Addendum No. 3

Date:	April 8, 2013
To:	Contractors
From:	Matthias Mueller – Program Director
Reference:	Bachelor Enlisted Quarters Facility Utah National Guard – Camp Williams, Utah DFCM Project No. 10281480
Subject:	**Addendum No. 3**

ADDENDUM THREE

BACHELORS ENLISTED QUARTERS FACILITY

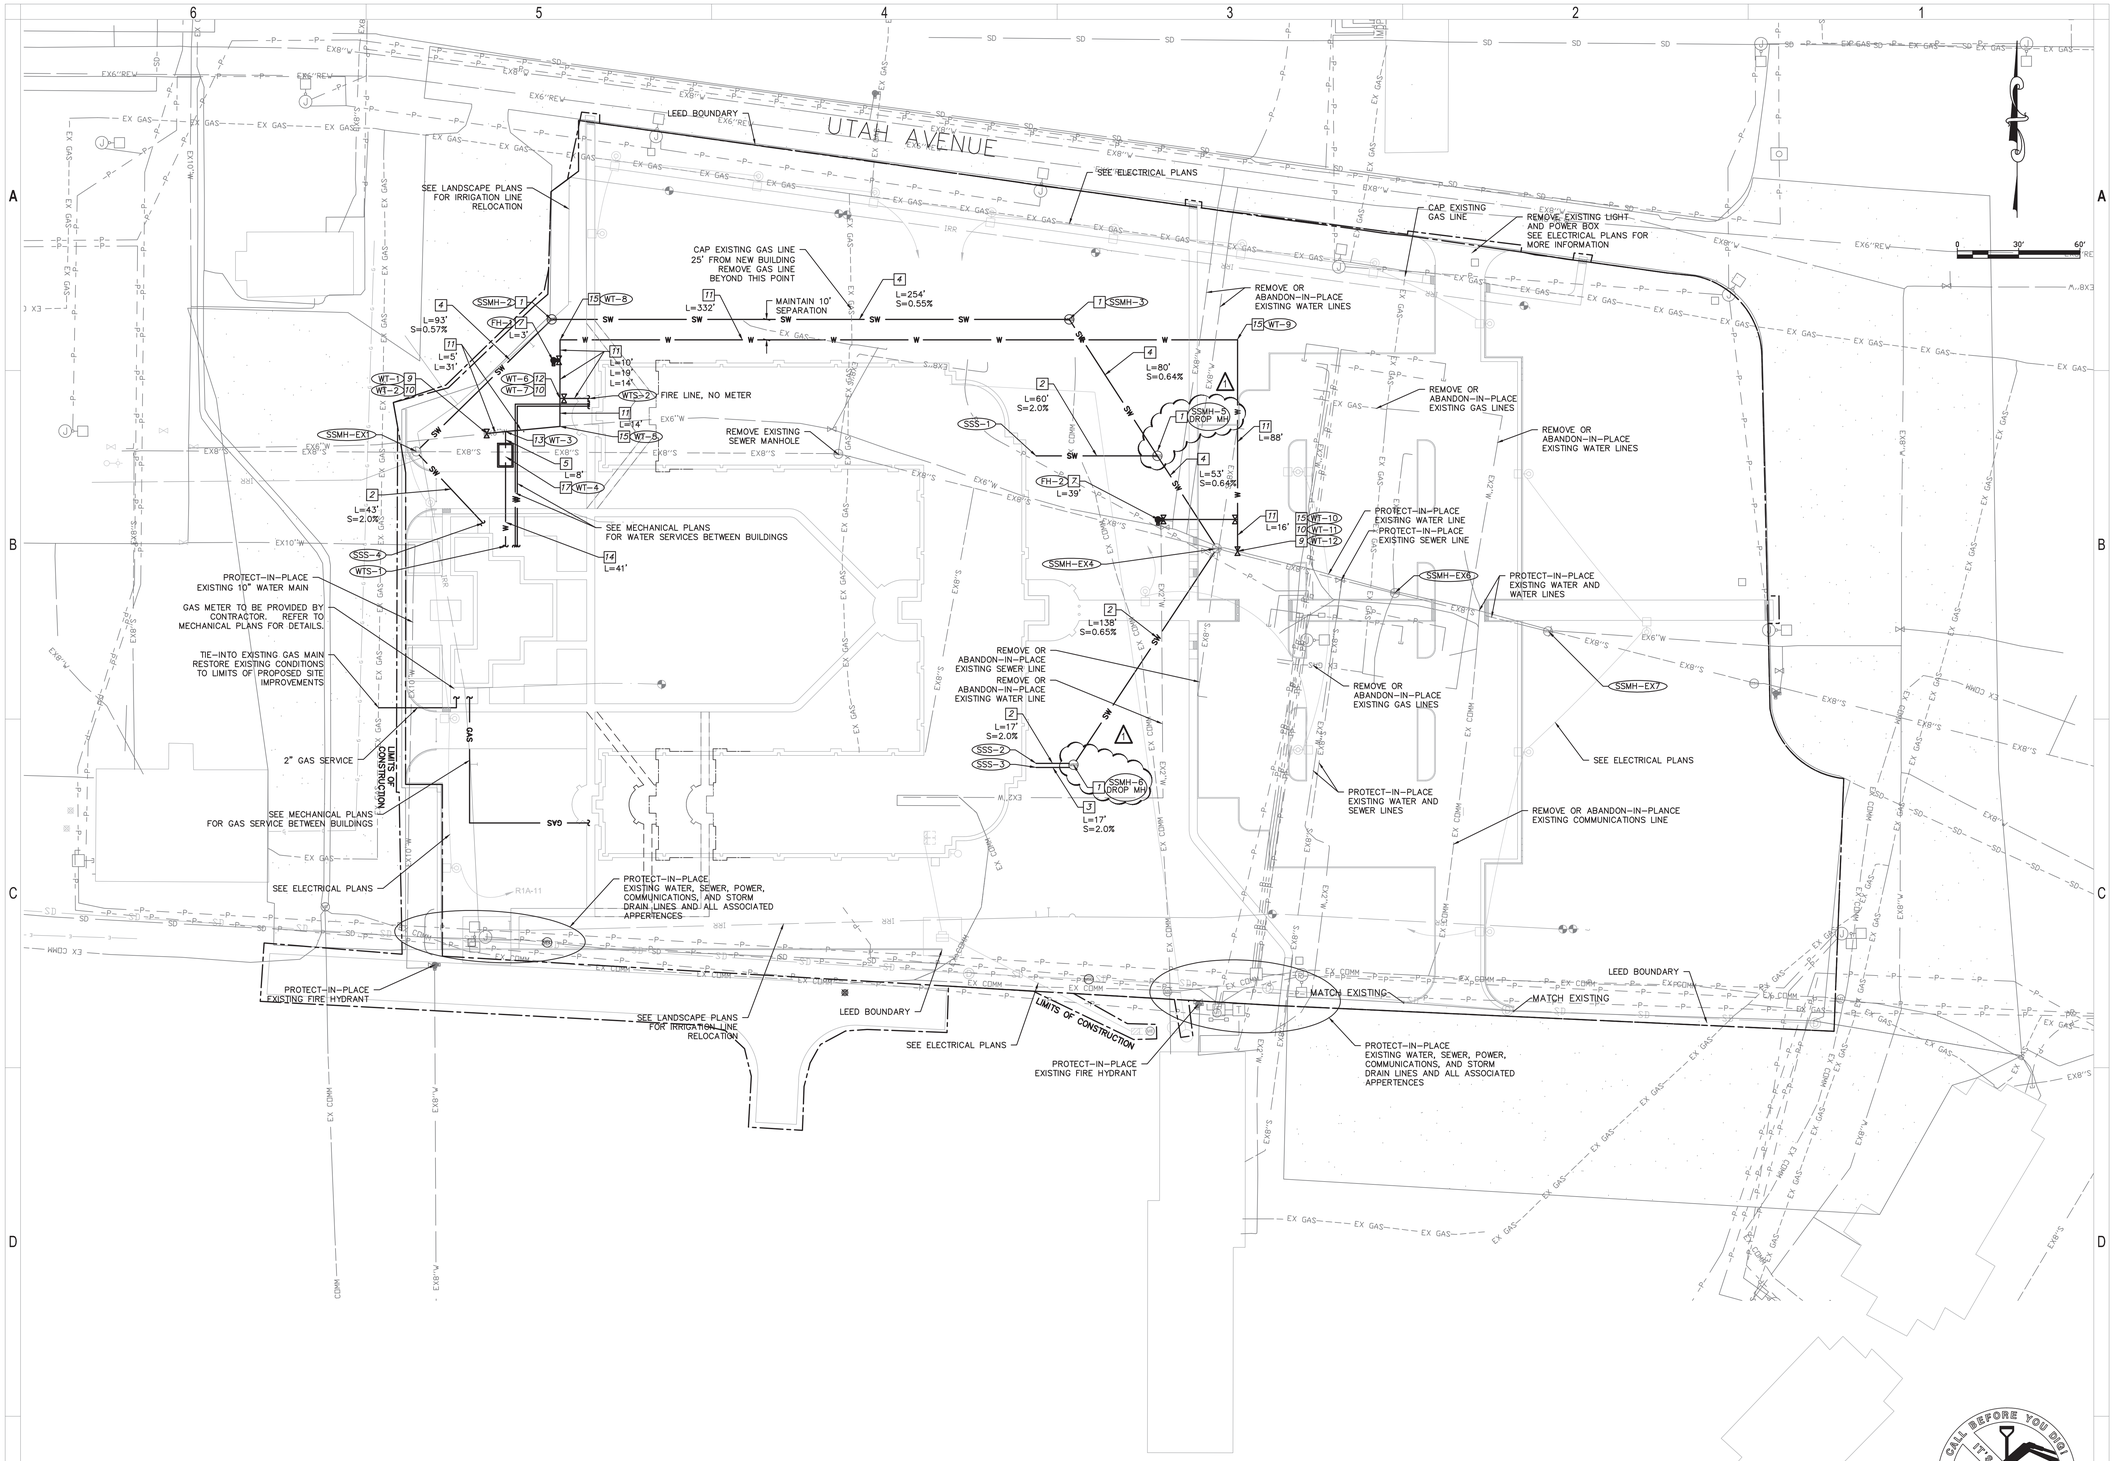
3.C03 Replace sheet CU101 with enclosed revised sheet CU101. The following are the updates made:

- Added two drop manholes for SSMH 5 and SSMH6. Laterals did not changed in depth or location.

DEMOLITION PLAN

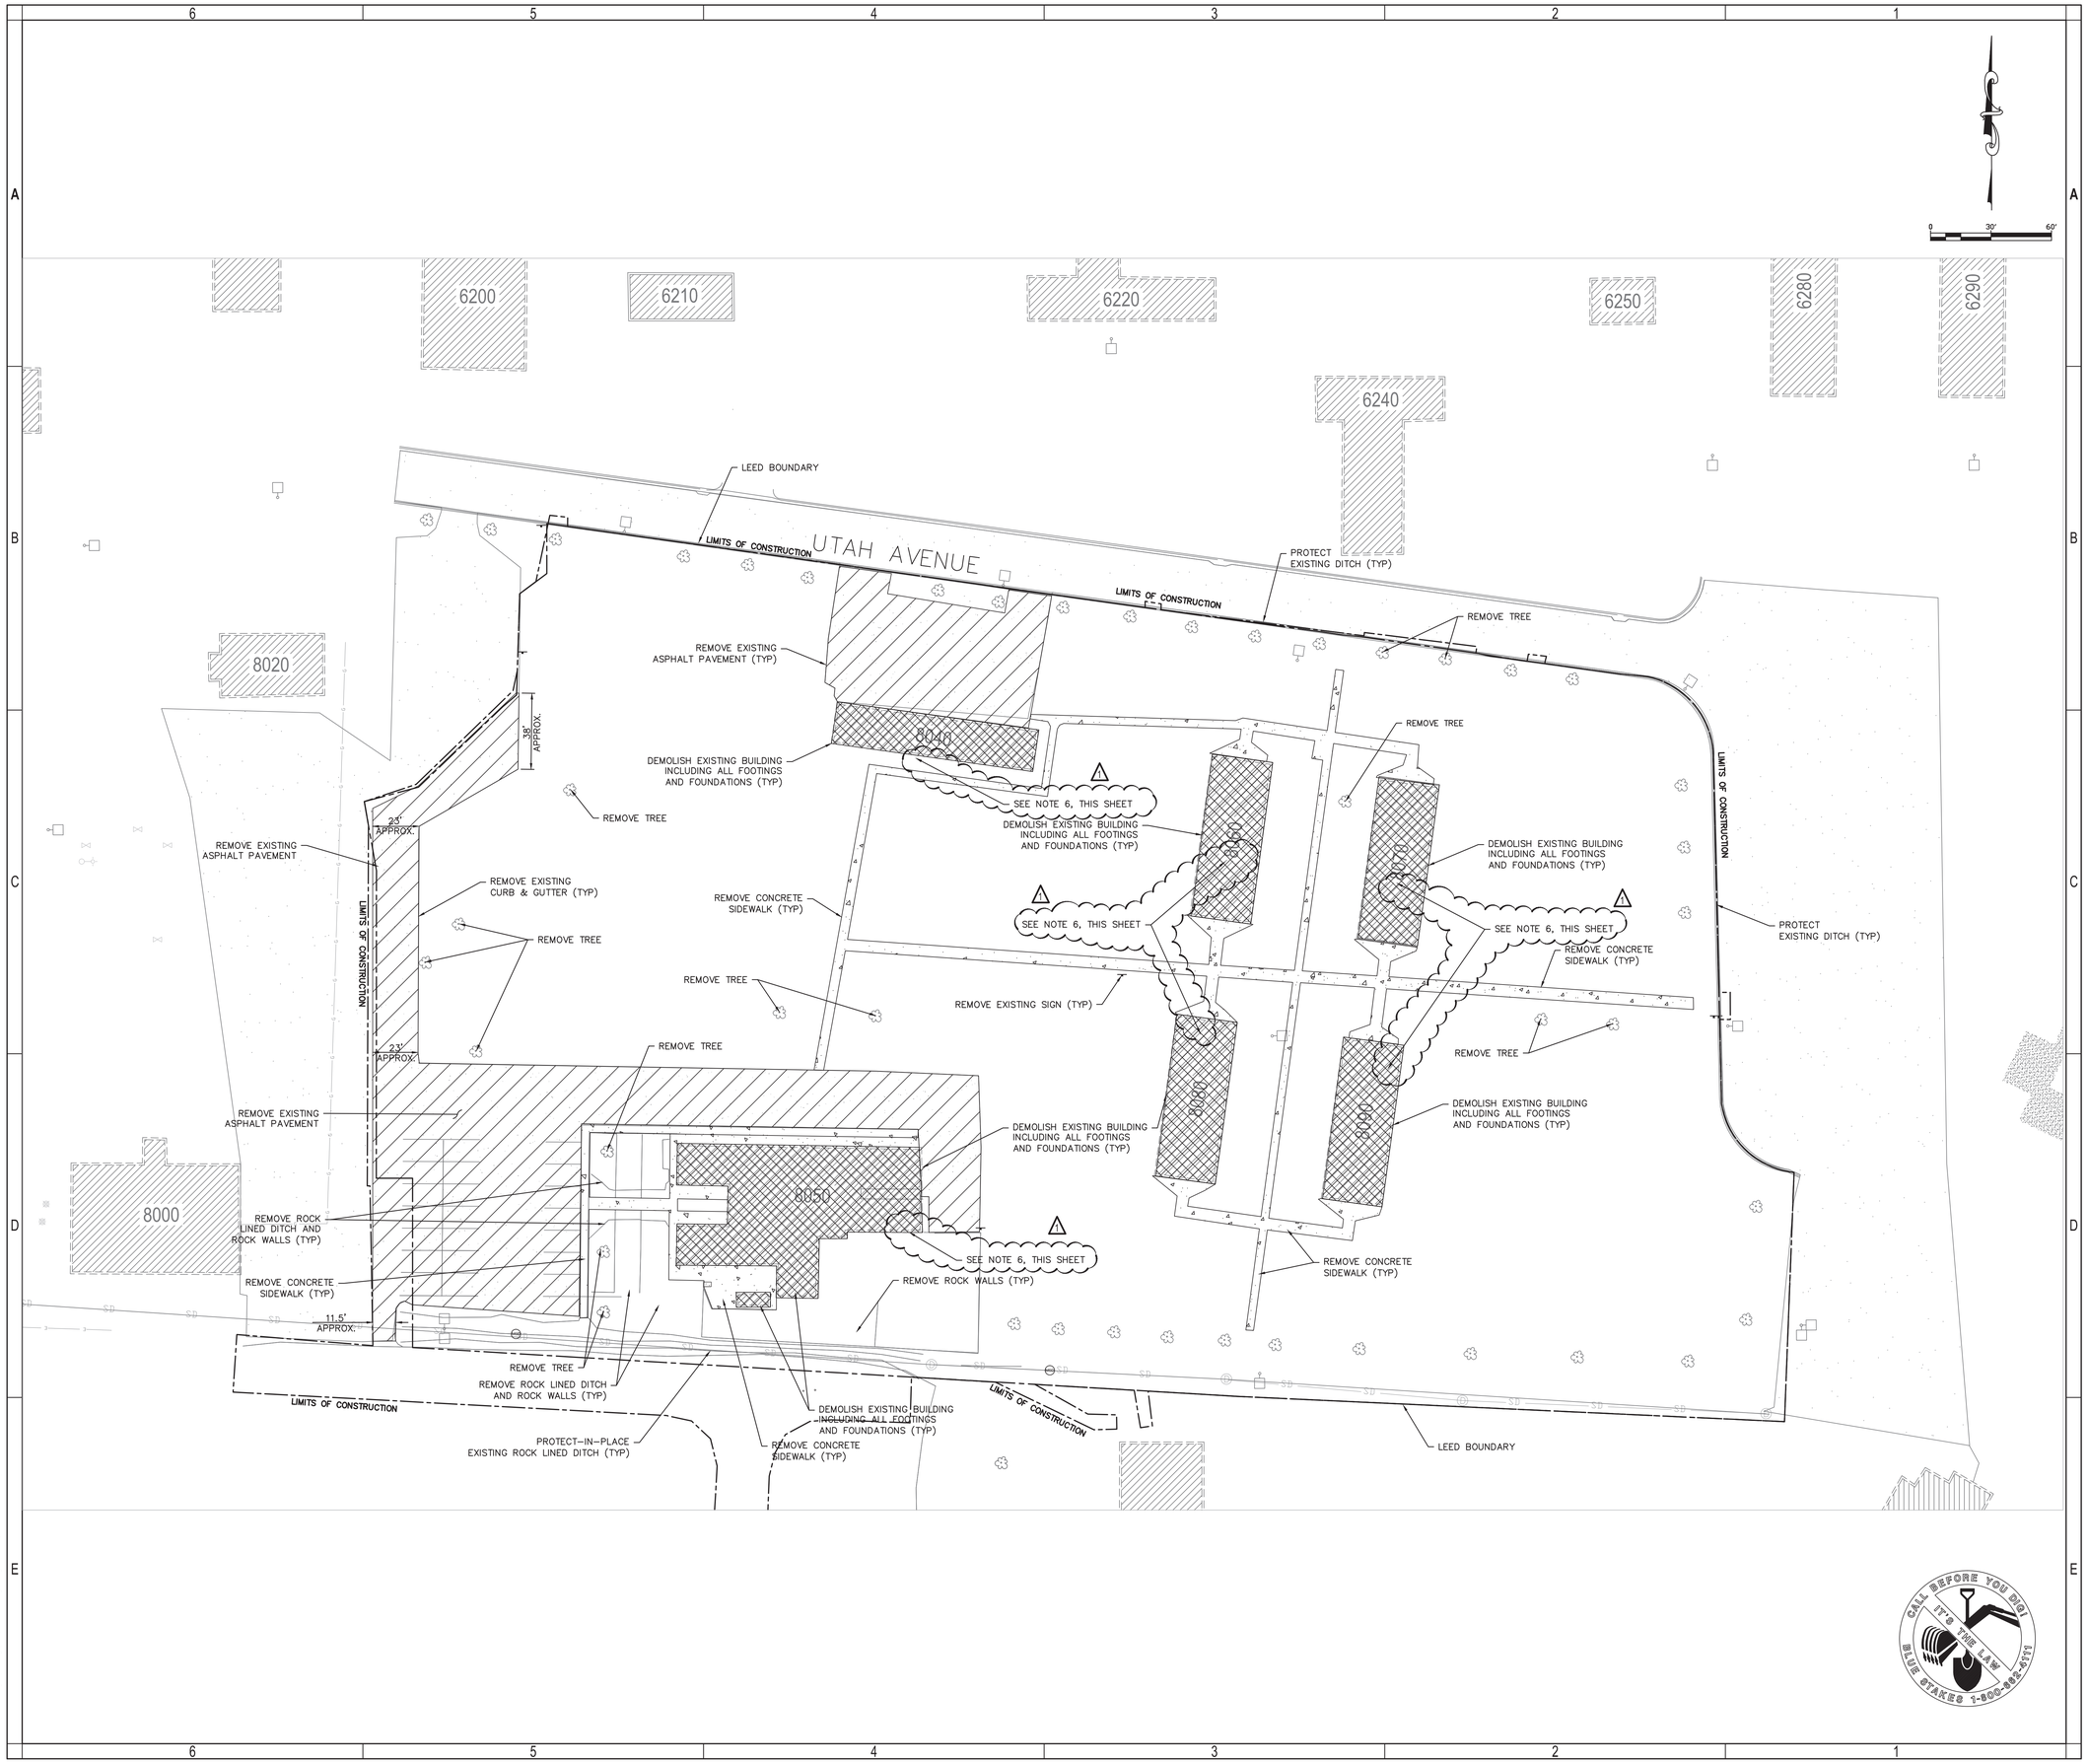
3.C01 Replace sheet CD101 with enclosed revised sheet CD101. The following are the updates made:

- Revised limits of construction
- Added note 6 referring structural fill for areas of demolition.

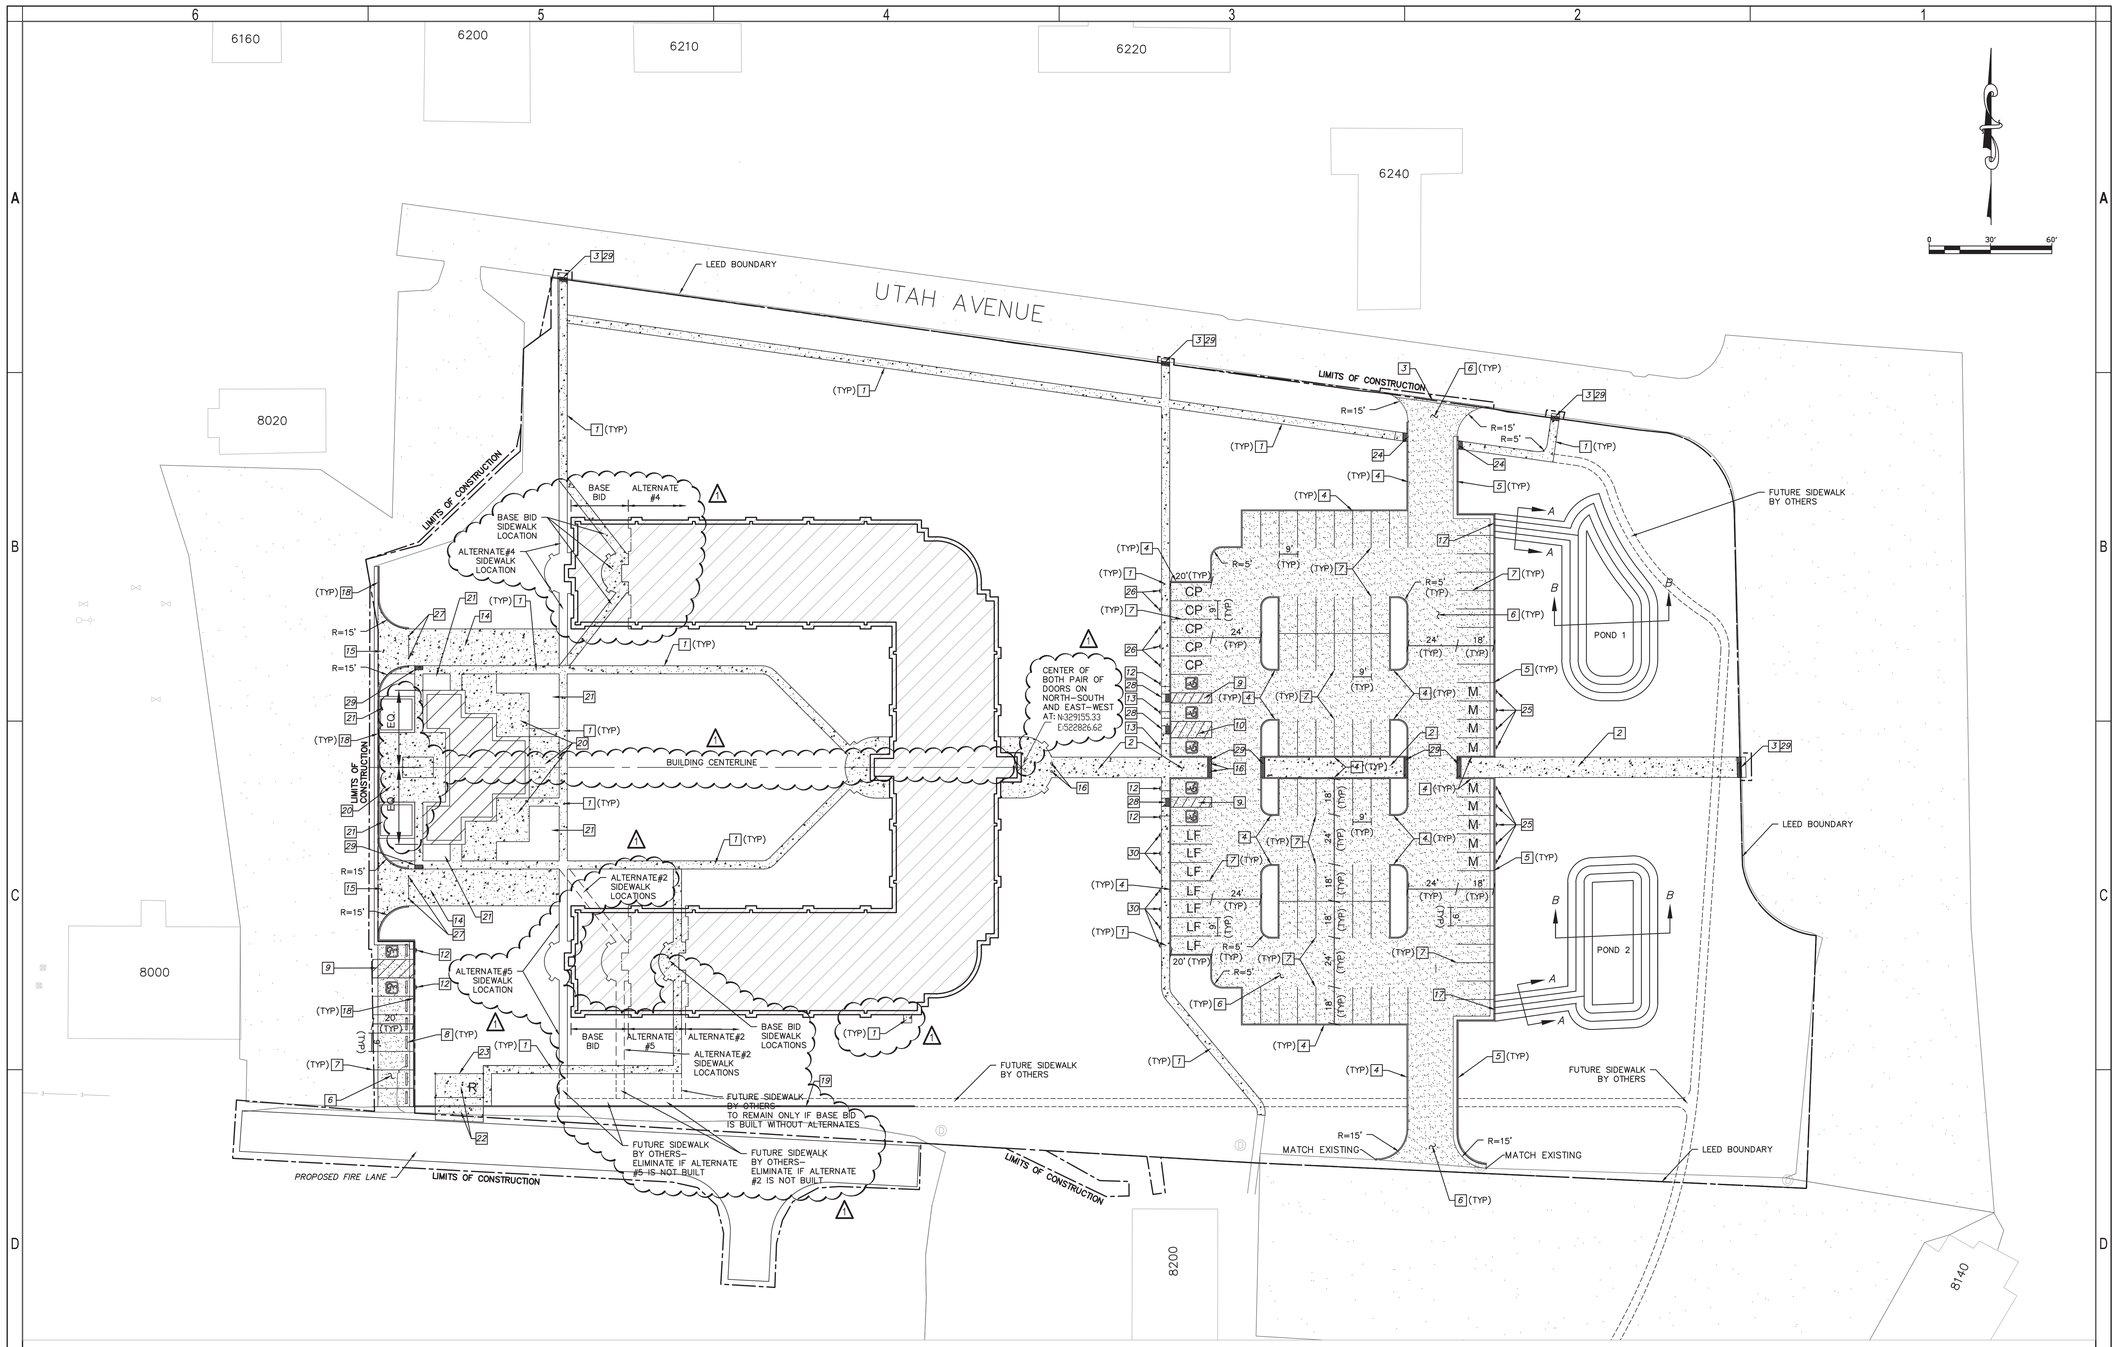
3.C02 Replace sheet CS101 with enclosed revised sheet CS101. The following are the updates made:

- Revised limits of construction
- Revised numbering for alternates and description
- Revised description of notes
- Located Northing/Easting for BEQ buildings.
